CUSTOMER LETTER

RE: IMPORTANT SAFETY RECALL INFORMATION REGARDING YOUR APRILIA RSV 1000 AND TUONO 1000 MOTORCYCLES

This notice is sent to you in accordance with the requirements of the National Traffic and Motor Vehicle Safety Act. The identification number of this recall is 08V-306.

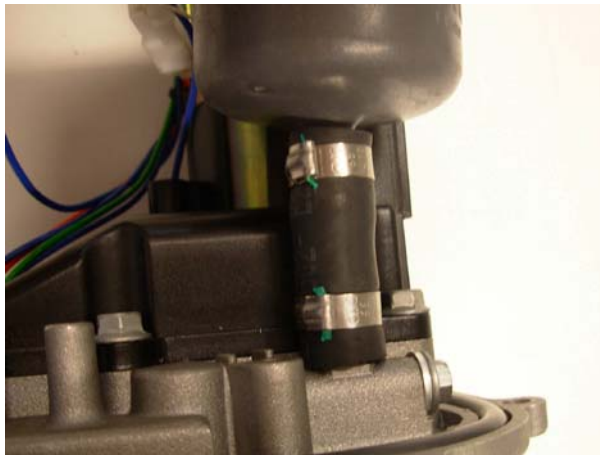
The fuel hose connecting the fuel filter with the fuel pump mounting plate may come loose. A loose fitting of this fuel hose to either the fuel filter or the fuel pump mounting plate will cause a reduction in, or loss of, fuel pressure to the engine. This reduction or loss of fuel pressure may cause difficulty in starting the motorcycle, or if already started and running, inconsistent running and possible stalling of the engine. Under certain circumstances these conditions could result in a crash, personal injury or death. These components are located inside the fuel tank of these motorcycles so no visible indicators of these leaks will be apparent to the owner/rider.

- Leaving the pump connected to fuel lines, release the two click clamps fastening the fuel hose between the mounting flange and the fuel filter. Discard old hose.

- Install the new fuel line AP8144476 with two new click clamps 890435.
- Refit the pump to tank, tighten screws finger tight and then tighten them in a cross pattern

TIGHTENING TORQUE 6 Nm
